To: Sherwin E. Turk
Deputy Assistant Chief Hearing Counsel, DELD

From: J. T. Chen, Geotechnical Engineer
EGEP/DE/NRR

Subject: APPLICANT'S RESPONSE TO STAFF AFFIDAVITS FILED IN THE
WATERFORD PROCEEDING

LOUISIANA POWER & LIGHT CO.
Waterford Steam Electric Station
BASE MAT
CRACK MAP
FIGURE 1

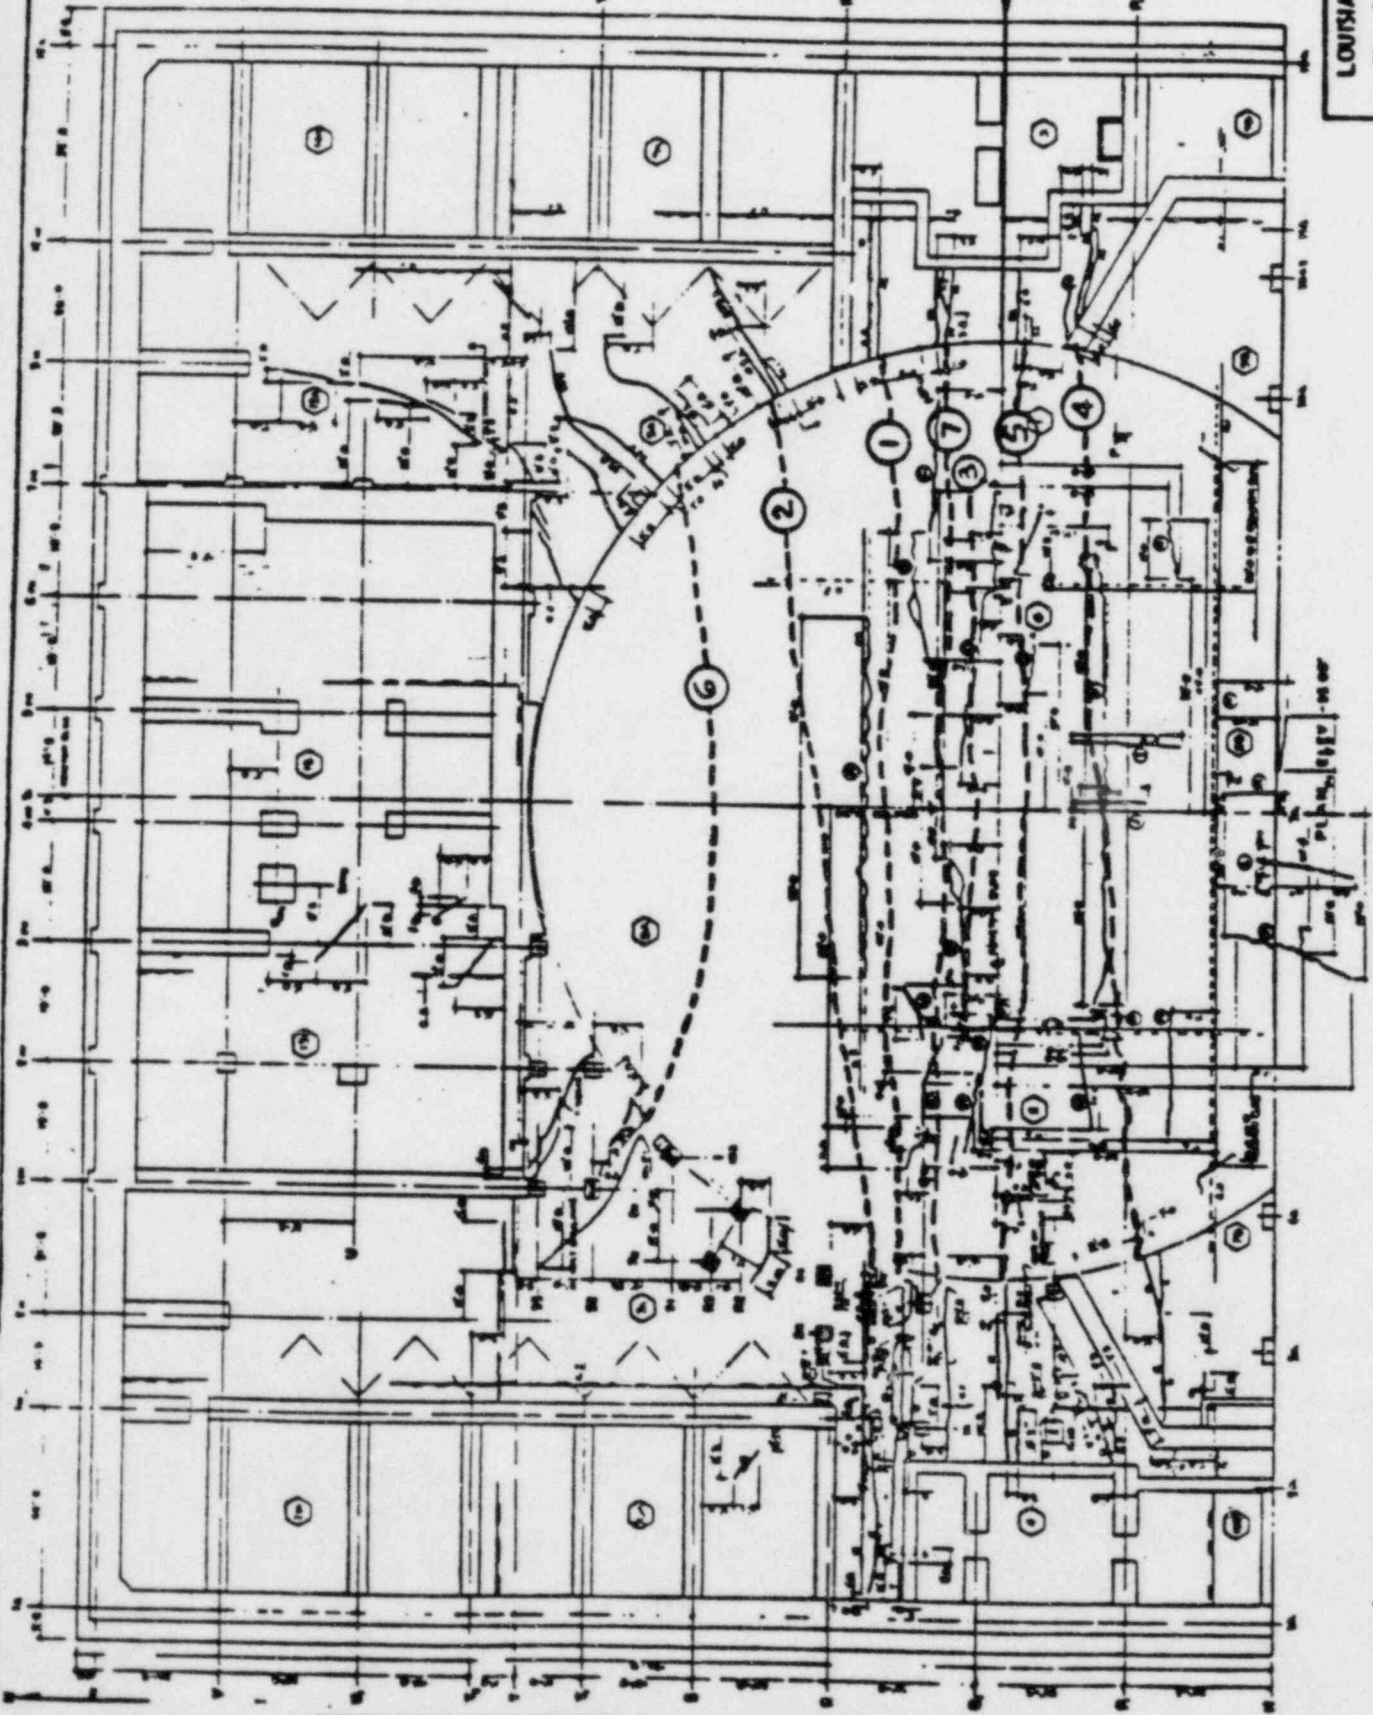
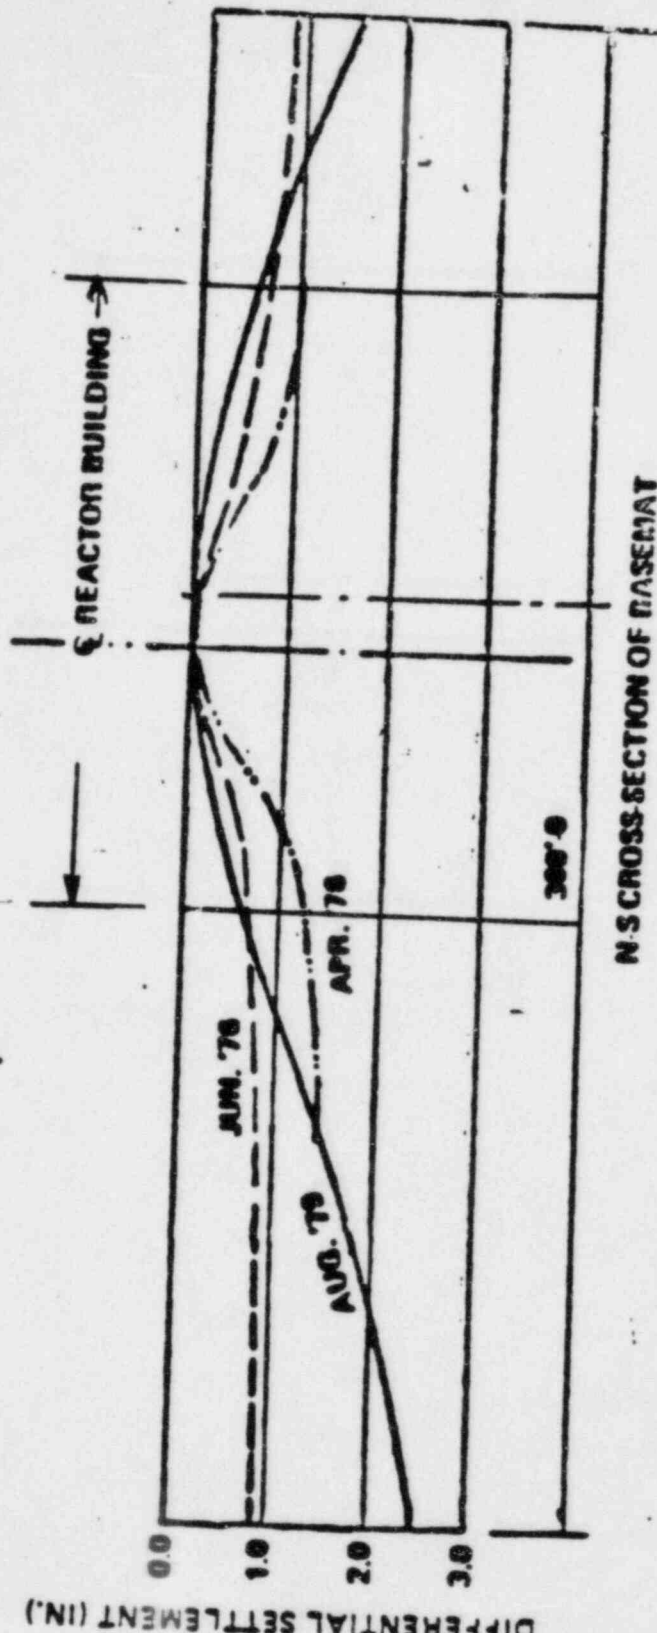
5. The cracking pattern was cited to be symmetric with the centerline of the reactor building (Ehasz Affidavit, page 15). However, the NDT results, as presented in Figure 1, clearly indicated that the cracking pattern is far from symmetric--5 major cracks were detected in the northern half of the reactor building while only 2 major cracks were detected in the southern half of the reactor building (see Figures 1 & 5).

Figure
 2

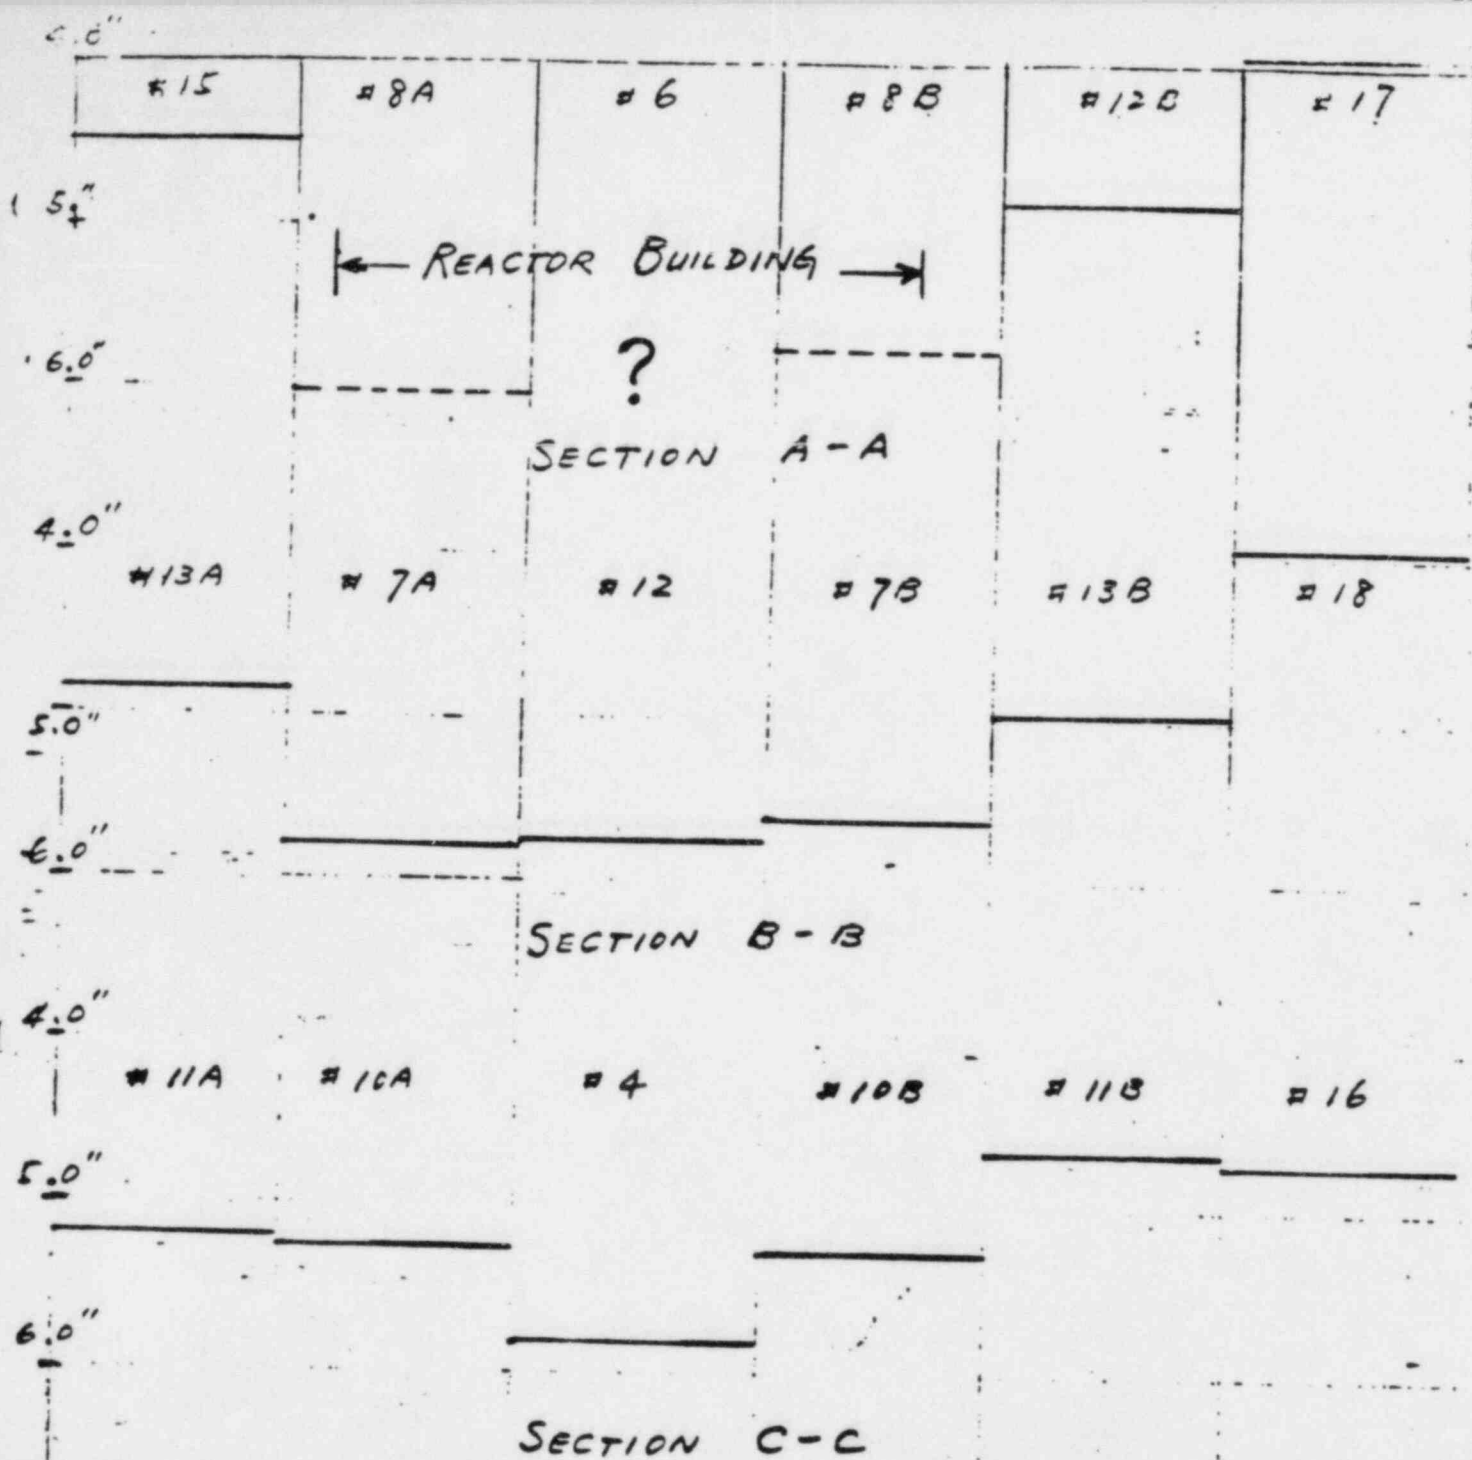
3. Figure 2 was used to illustrate the convexity of the basemat during construction (Ehasz Affidavit, page 12). However, the validity of this figure is questionable because it lacks measured data in the containment area to back it up. Based on LP&L's March 1984 submittal, settlements within the containment area were not surveyed since mid March 1976 due to the inaccessibility to the surveying pins. Therefore, the "actual" settlements within the containment area as shown in Figure 2 was imagined by LP&L, not necessarily be real. The measured settlements outside the containment area, however, showed that the top of the basemat has a concaved shape (see Figure 3). The data available directly measured data within the containment area (March 1976 data), also, showed a somewhat concaved shape (see Figure 4). Therefore, LP&L's statement about the convexity of the basemat, "As illustrated in Figure 2...reactor building centerline.", is somehow questionable!
